SUBJECT: DEMONSTRATION / DELIVERY HOLD - Compliance Recall 17C04
Certain 2017 Model Year Mustang Vehicles
Left-Hand Interior Door Handle Spring Inspection

CERTAIN 2017 MODEL YEAR MUSTANG VEHICLES — LEFT-HAND INTERIOR FRONT DOOR HANDLE SPRING INSPECTION

FIGURE 1

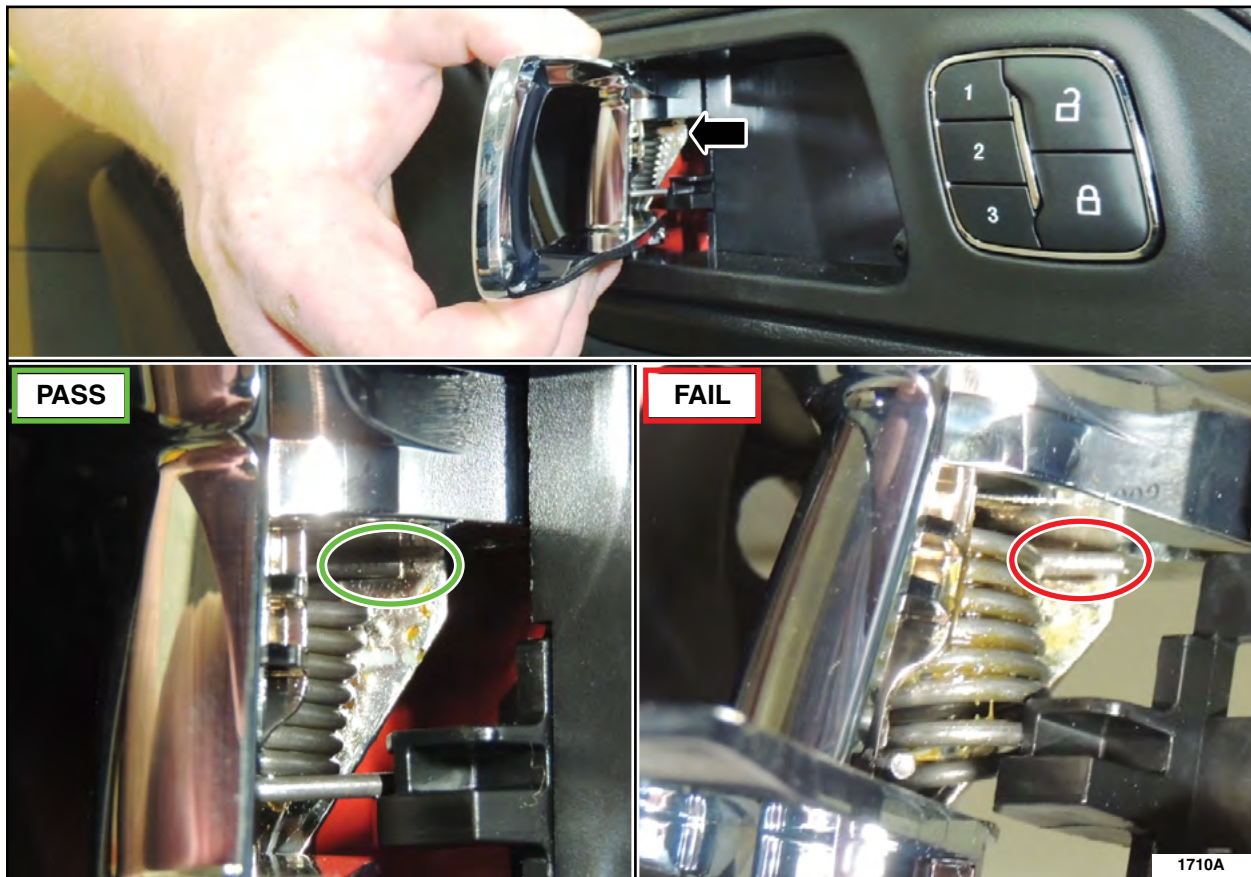
1. Inspect the position of the spring inside the left-hand (LH) interior front door handle. See Figure 1.

- If the spring is correctly installed, the spring tail will be approximately 3 mm (0.1 in) from the edge of the door handle spring wall. No service is required.
- If the spring tail is flush or above the edge of the door handle spring wall OR the spring is missing, proceed to Step 2.

FIGURE 2

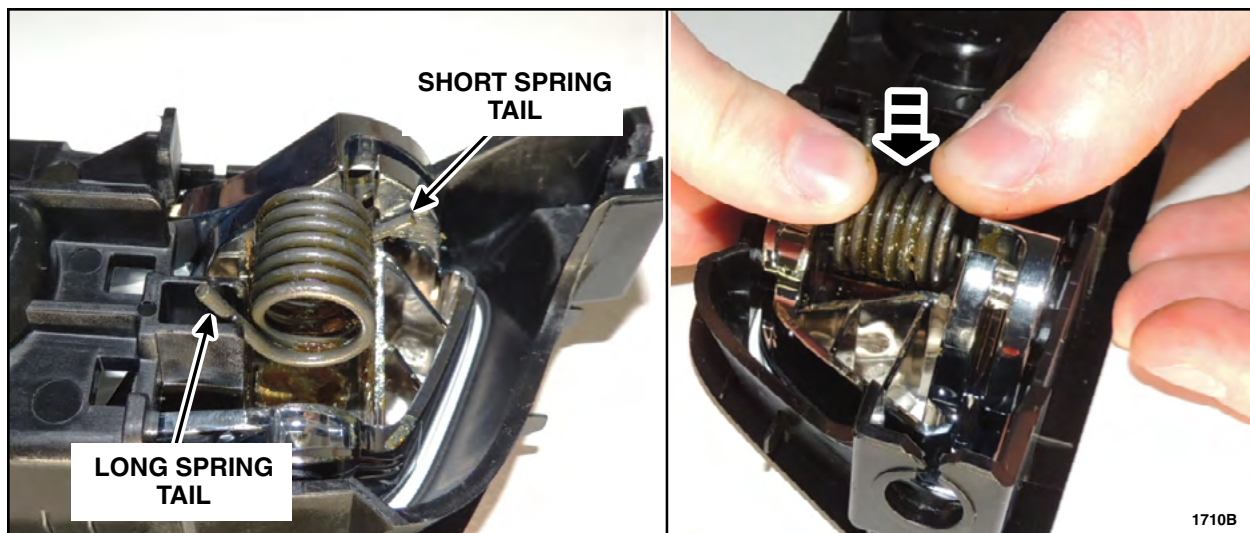
4. Reinstall the spring into the LH interior front door handle in the correct orientation. Press downward until the spring is fully seated. See Figure 2.

- When installed correctly the longer spring tail should face forward, toward the front of the vehicle when the handle is reinstalled.
